SUBJECT: STAFF OBSERVATIONS OF TESTING FOR GENERIC SAFETY  
ISSUE 191 DURING JULY 22 TO JULY 24, 2009 TRIP TO THE ALION  
HYDRAULICS LABORATORY

Observations of Testing at Alion Science and Technology Hydraulics Laboratory  
July 22 to July 24, 2009  
NRR/DCI/CSGB

**Figure 1. High Temperature Vertical Loop**

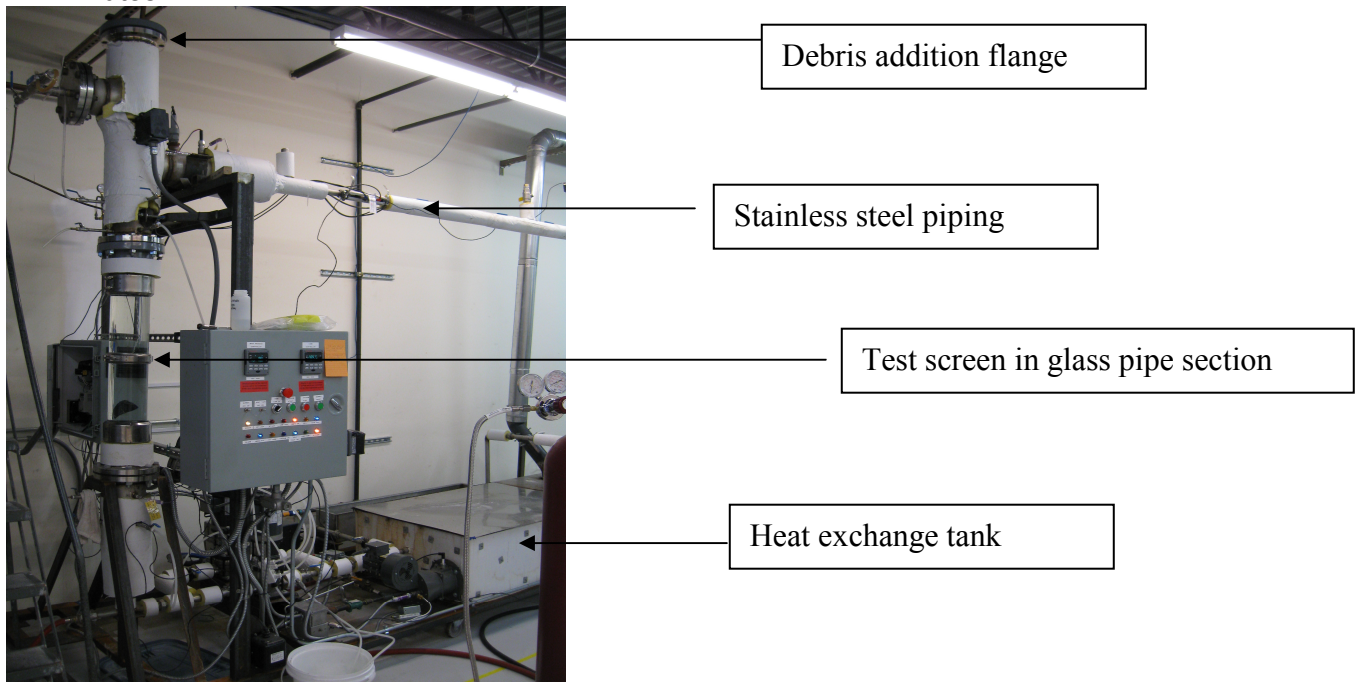
Figure 1 provides an overall view of the HTVL piping loop arrangement. The test loop contains a pump, stainless steel piping, a heat exchange tank, various instrument ports, a top flange connection and a clear glass test section that holds a horizontal, 3/32-inch diameter hole perforated plate test section. Heating is controlled through the use of a gas burner coil located at the heat exchange tank and by heat trace on the stainless piping. Cooling is achieved by ice addition to the heat exchange tank. Addition of particulate, fiber, trisodium phosphate (to adjust pH) and boric acid are made through the flanged top connection above the filter housing. During testing, chemicals are added through a port located downstream of the heat exchange tank to allow for mixing of chemicals prior to reaching the debris bed. For the Vogtle tests, the target volumetric flow rate was 13 gpm, which resulted in a one volume turn-over time of approximately 1.2 minutes.

**Figure 2. Vogtle Chemical Effect Test 1 Post-Test Bed Appearance**

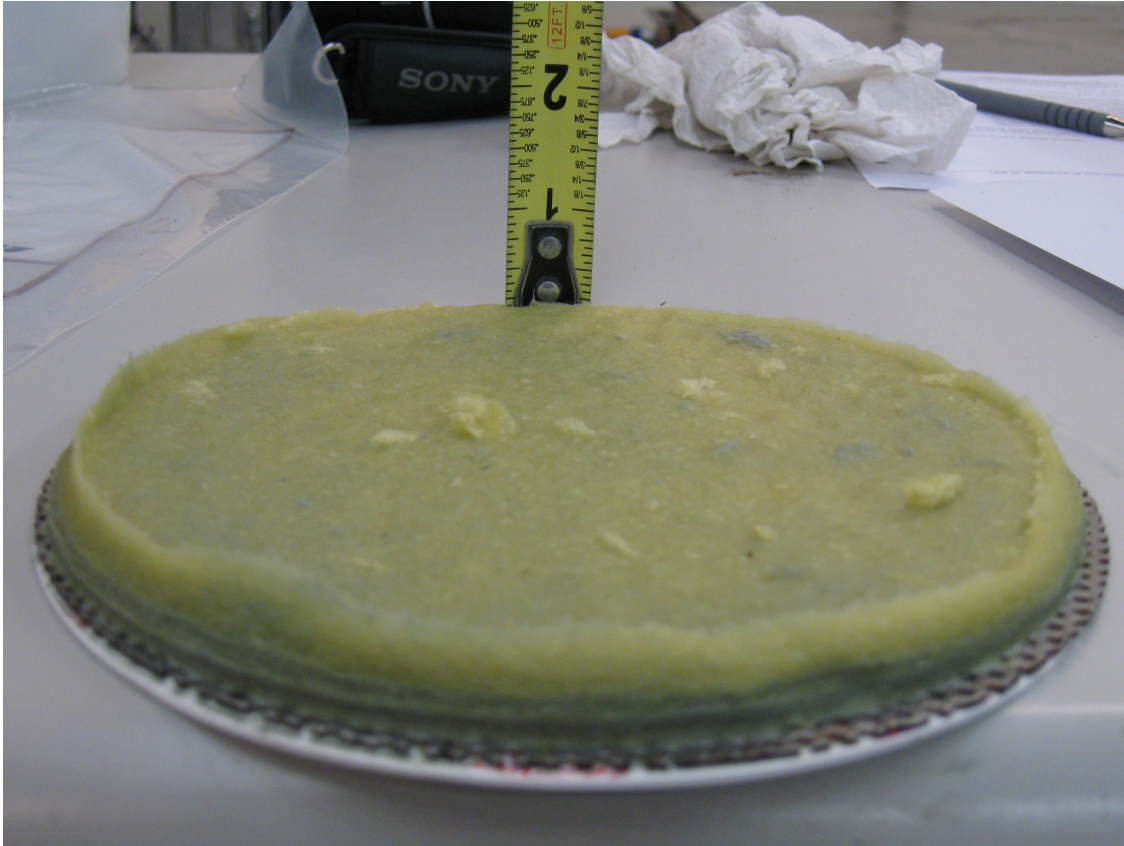
The NRC staff observed the completion of Vogtle's chemical effects Test 1 on July 22. Total pressure drop across the debris bed was approximately 4 feet of water when the test was ended. The staff observed the system drain down and removal of the debris bed following the test. Figure 2 shows the post-test debris bed for the first chemical effects test following removal from the glass section. The overall bed was fairly uniform with some clumps of fiber present on the top of the bed. Based on a cross section appearance, the bed had a particulate-rich darker bottom third section and a more yellowish fiber (less particulate) upper two-third layer.
